**GOVERNMENT OF THE DISTRICT OF COLUMBIA  
DEPARTMENT OF TRANSPORTATION**

**MEMORANDUM**

**SUBJECT:** ZC Case No. 13-08 – 1333 Alabama Avenue SE – Congress Heights Metro

Figure 1 Site Design and Access (Source: Well & Associates)

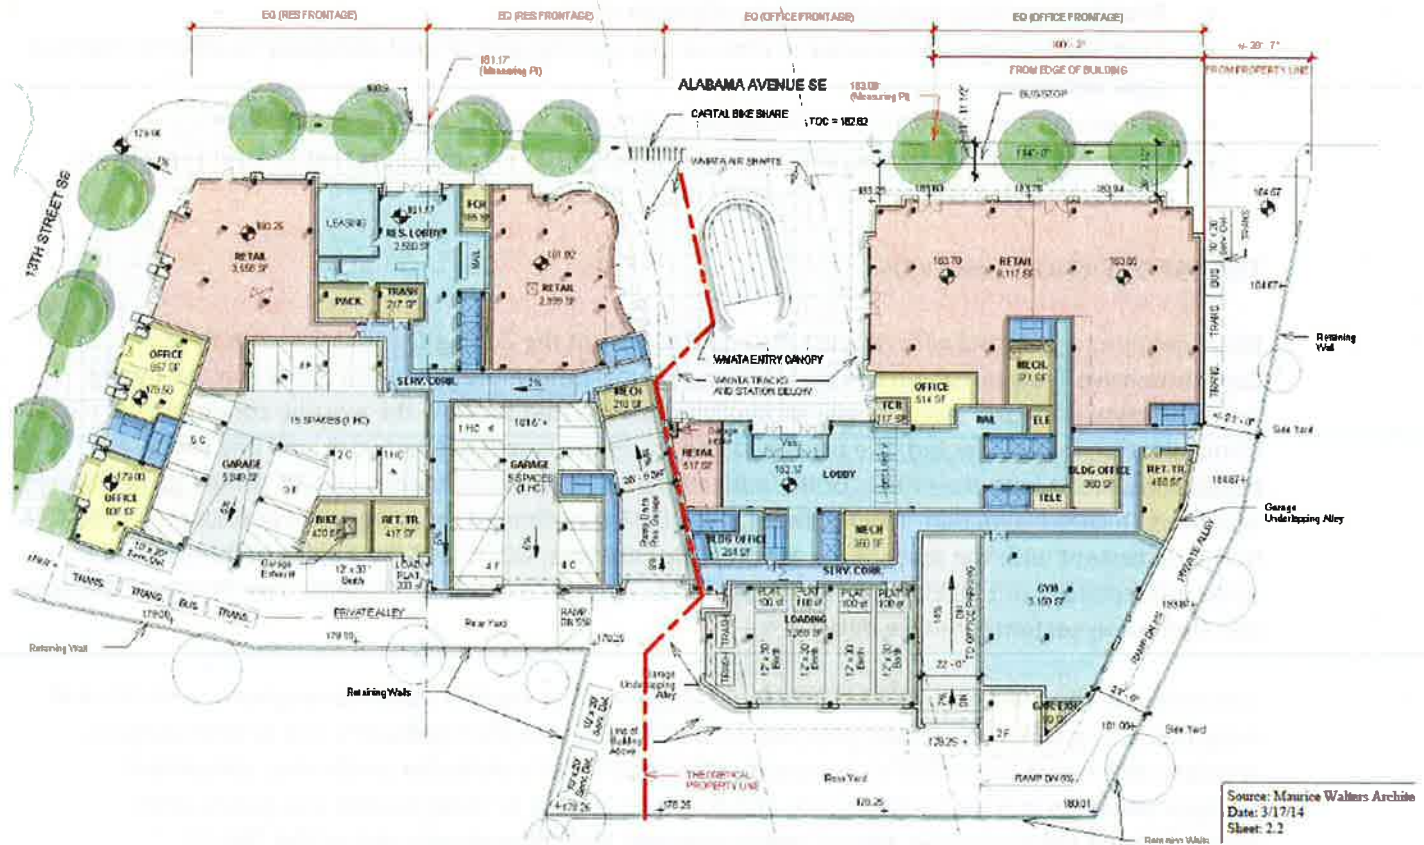
The site is located on top of the Congress Heights Metro station and will envelope the southern entrance on Alabama Avenue. Pedestrian access will occur on both Alabama Avenue and 13<sup>th</sup> Street at various building entrances. A new private alley with a curb cut on 13<sup>th</sup> Street SE and Alabama Avenue is proposed and meets DDOT standards. All loading and off-street parking access will occur via the private alley. See Figure 1 below for details:

The Office Building meets all zoning loading requirements, while the Residential Building seeks relief from the 55 foot loading berth requirement. In lieu of the 55 foot berth, the Residential Building will provide a 30 foot loading berth and a loading management plan outlined in their CTR. All loading facilities are designed to accommodate front-in/front-out movements in compliance with DDOT standards. DDOT finds that the Loading Management Plan as proposed sufficiently addresses loading impacts.
